SACRAMENTO ARCHITECTS COLLABORATIVE  
722 Alhambra Boulevard  
Sacramento, California 95816

ADDENDUM #1

SACRAMENTO COMMUNITY CENTER COMPLEX

13th and 14th Streets,  
J and L Streets,  
Sacramento, California

ADDENDUM NO. 1  
ITEM #12  
BALCONY GRAB BARS

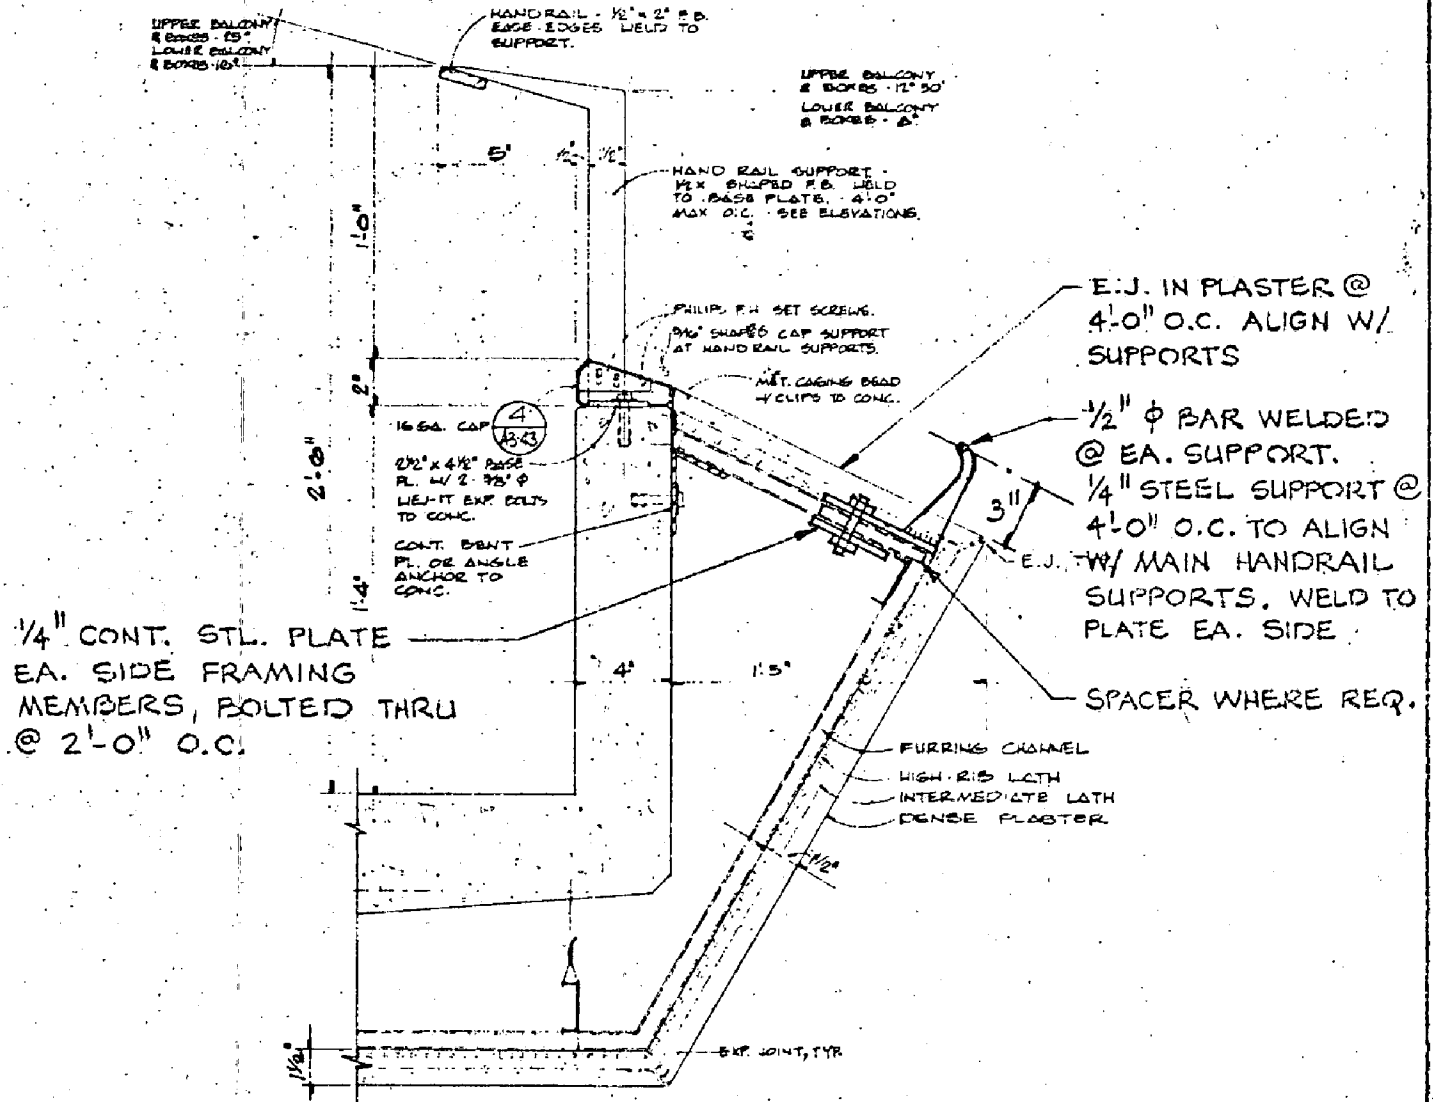
BALCONY GRAB BARS

Reference: Drawings - Sheet A3-43  
Addenda Drawing No. 1  
Specifications - Volume I  
SECTION 5E - MISCELLANEOUS METAL  
Page 5E-1

"Delete Detail 1 on Sheet A3-43." Replace that detail with  
Addenda Drawing No. 1.

Include material under Handrails and Railings in Section 5E.

ADDENDUM NO. 1  
ITEM # 13  
VERTICAL SHAFT COVER

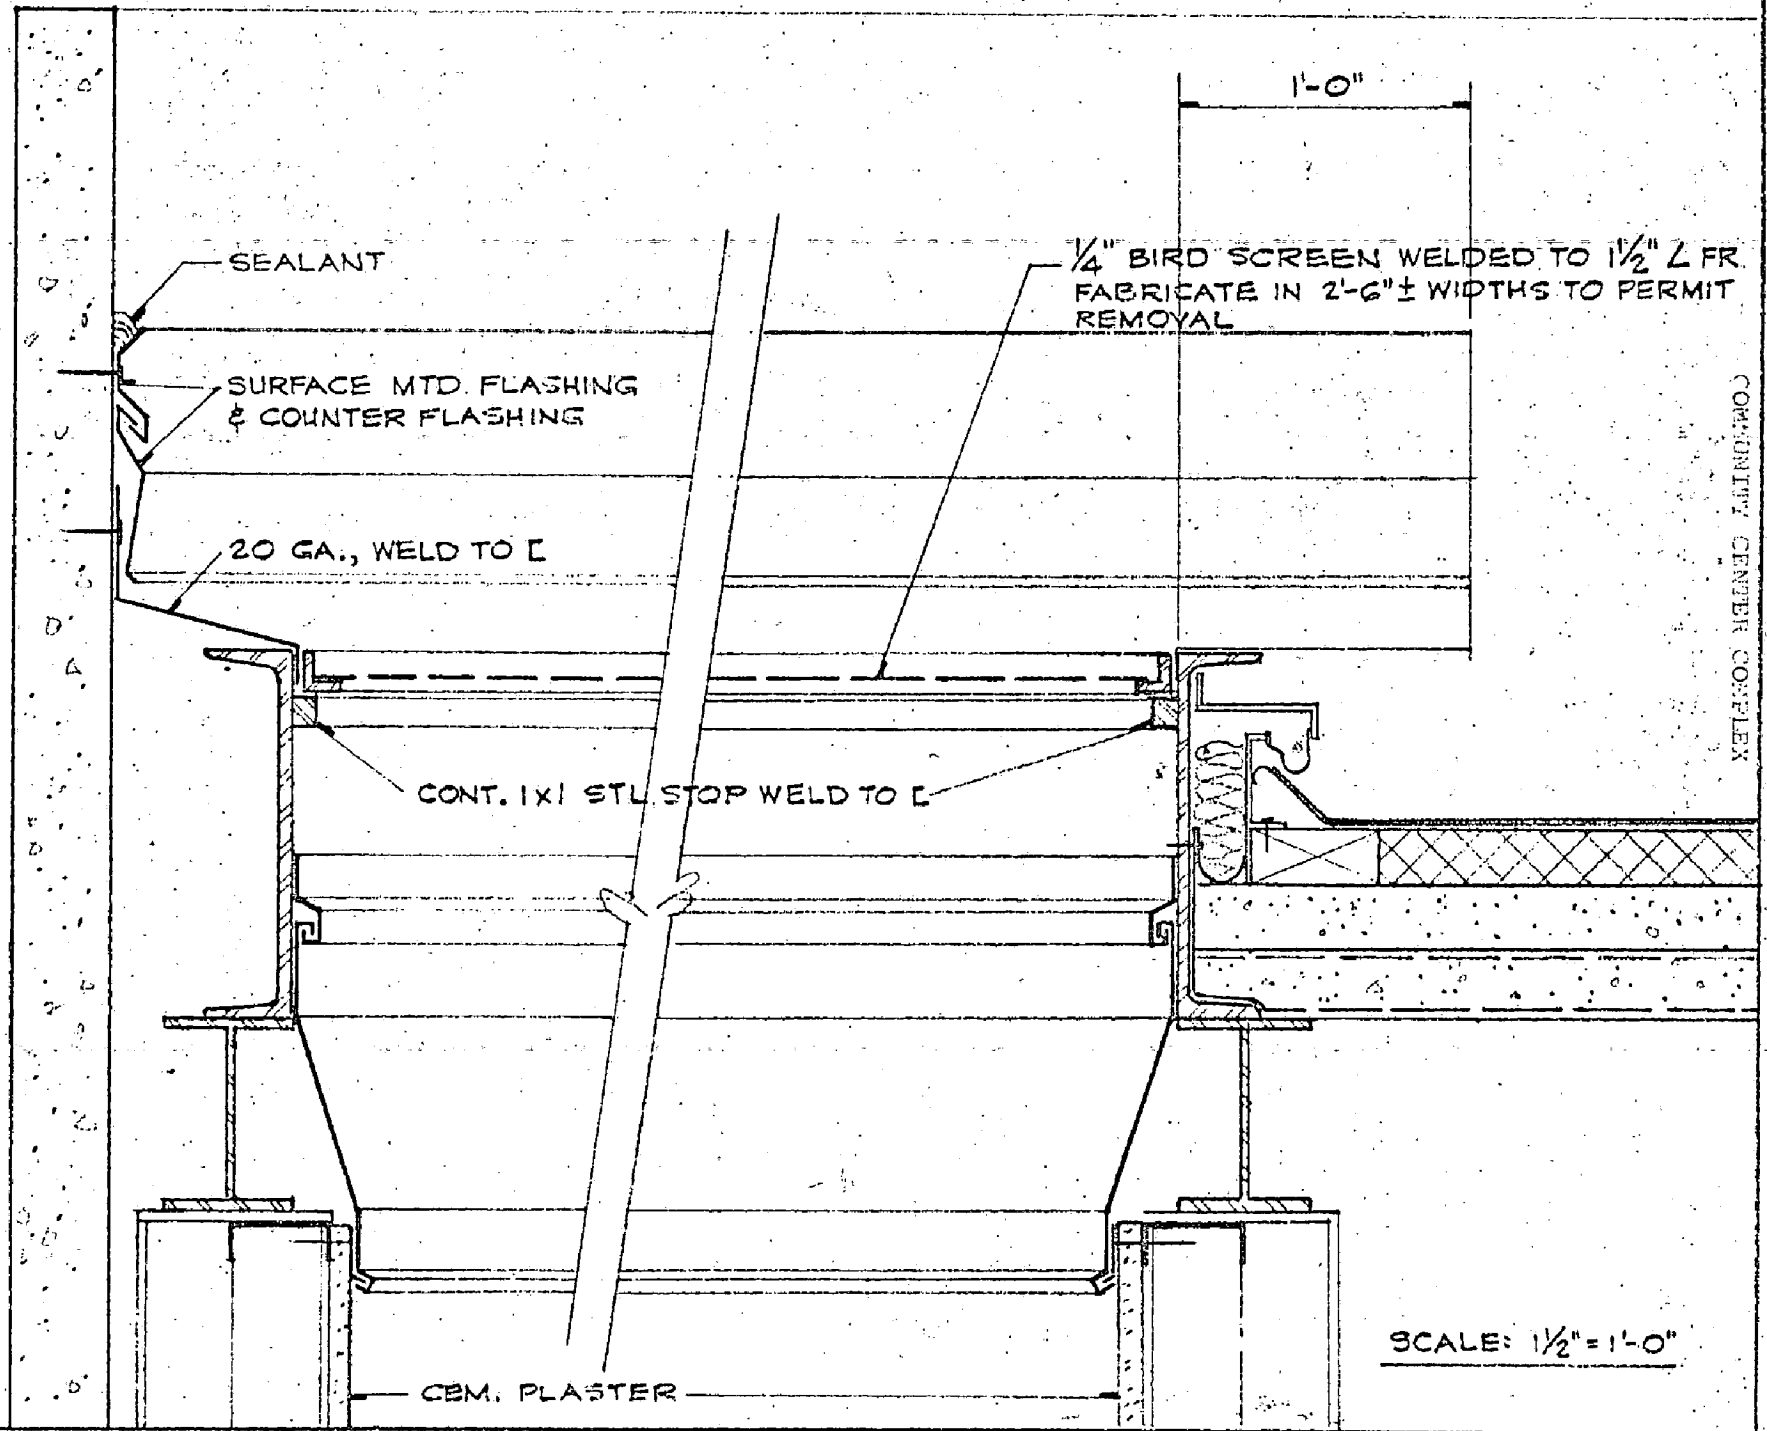
Drawings - Sheet A3-7  
Addenda Drawing No. 2

"Modify Section B of Sheet A3-7, vertical shafts 04 and 09,  
to conform to Addenda Drawing No. 2"

Add Line 33: "1/4" galvanized bird screen"

Change wall material at shafts 04 and 09 from Hard Coat Plaster  
as shown to cement plaster system shown in Addenda drawing.
